Modification of the clamping yoke on product families LM 5.0x, LL 6.35, LL 9.52 and WGK 4

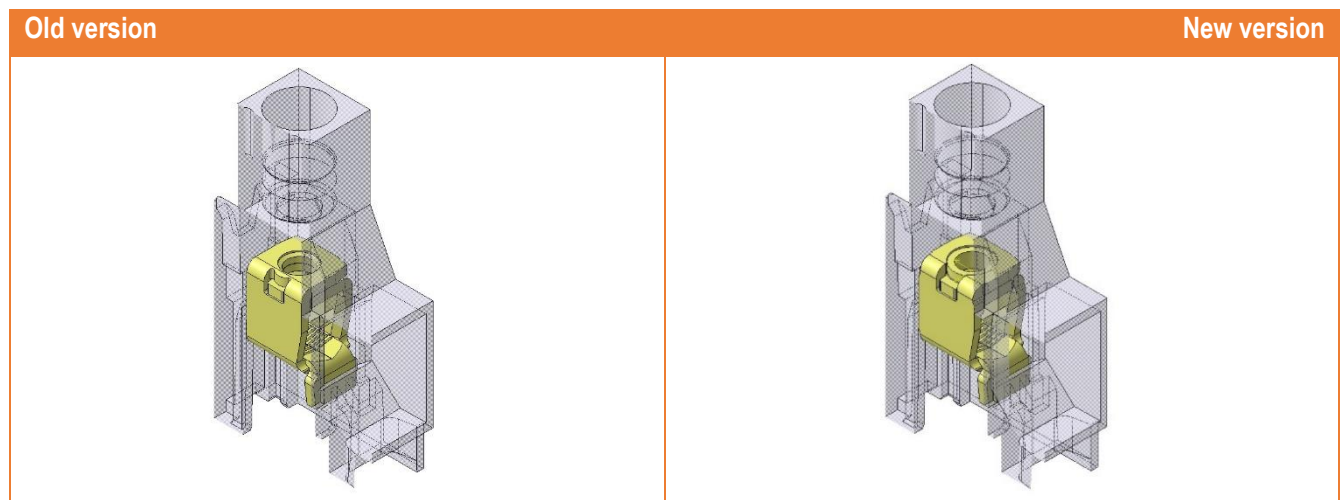
The thread of the clamping yoke is made in 2 sheet metal layers in the old version. In the new version of the clamping yoke, the thread is made from one piece of sheet metal by using a pull-through.
